PLAN CHANGE REQUEST 3

DATE: 03/03/2022 PERMIT NO./REF NO: E-20-0612

1. PROJECT: Furrucci Junior High Addition ADDRESS: 3213 Wildwood Park Drive
2. OWNER: Puyallup School District EMAIL: vandelj@puyallup.k12.wa.us
3. DESIGN ENGINEER: Sitts & Hill Engineers, Inc. EMAIL: rickh@sittshill.com
4. CONTRACTOR: Pease & Sons, Inc. EMAIL: brandon@peaseandsons.com
5. ORIGINATOR OF REQUEST:
☒ OWNER ☒ DESIGN ENGINEER ☒ CONTRACTOR ☐ CITY OF PUYALLUP
6. DOES THIS REQUEST REQUIRE A DEVIATION FROM AN EXISTING CITY STANDARD? ☐ YES ☒ NO
7. IF YES, PLEASE SUBMIT AN ALTERNATIVE METHODS FOR CONSTRUCTION MATERIALS REQUEST APPLICATION (AMR).
8. IF NO, PLEASE COMPLETE THE FOLLOWING:
9. APPROVED CIVIL PLAN SHEET NUMBERS AFFECTED: C7.01
10. WHAT PART OF THE CITY AND/OR DEVELOPMENT INFRASTRUCTURE IS BEING AFFECTED?
☒ ROAD ☐ STORM ☐ WATER ☐ SANITARY ☐ GRADING ☐ EROSION CONTROL

E-20-0612. PCR003.
Ferrucci Jr High Addition.
March 2022.

WILDWOOD PARK
DRIVE STREET LIGHT
PLAN - WEST

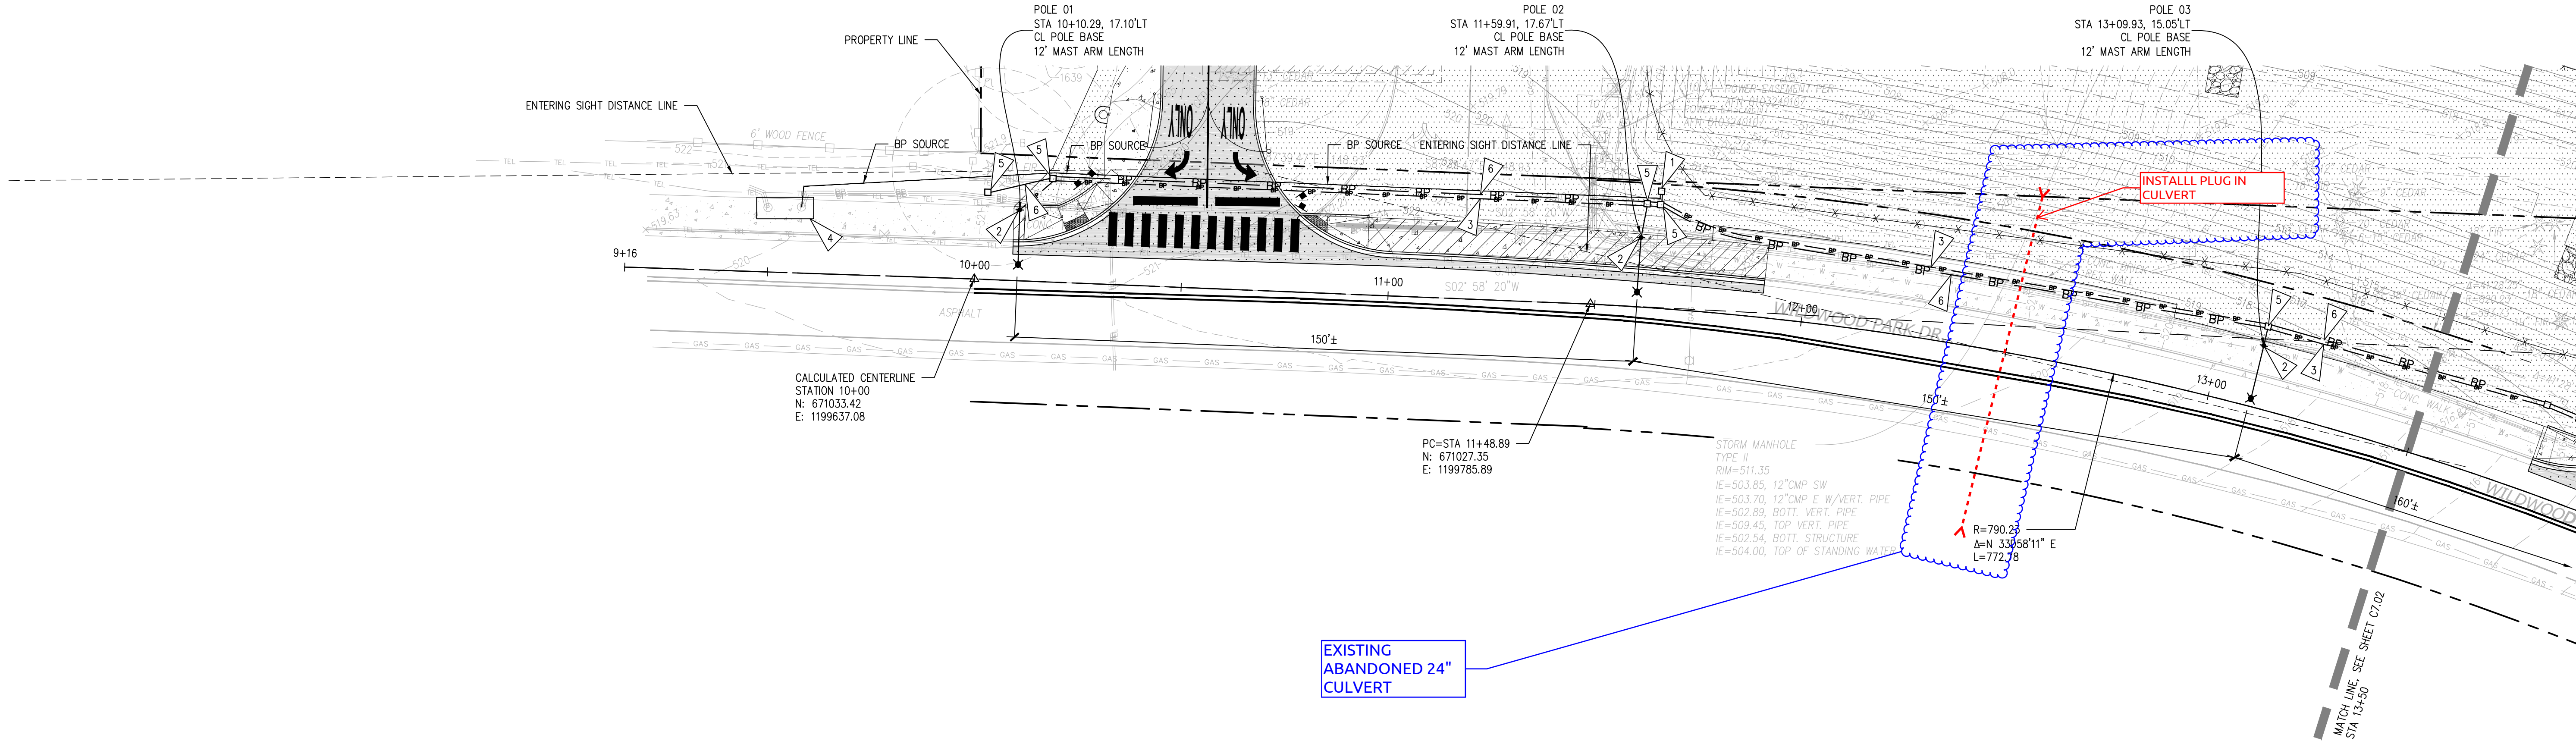
11. DESCRIBE THE CHANGE BEING REQUESTED: (ATTACH ADDITIONAL INFORMATION AS NECESSARY)
During construction of the onsite infiltration pond, the north end of an existing abandoned 24" diameter concrete culvert was found crossing Wildwood and discharging into the proposed pond. In the pre-developed condition, the north end of the existing culvert was buried and not flowing or discharging any stormwater. In the developed condition the north end is exposed and stormwater flows have been continuous (estimated at 10-20 gpm), flowing south to north. We cannot find the south end, but there is ponding stormwater on the Pierce College site and a wooded forest. The culvert stormwater flows to the proposed pond must stop. They are not considered in any calculations nor do we see any adverse effect from plugging the culvert from the school side since the culvert has been plugged for many years with the soil overburden. Request approval to plug the culvert from the school side.
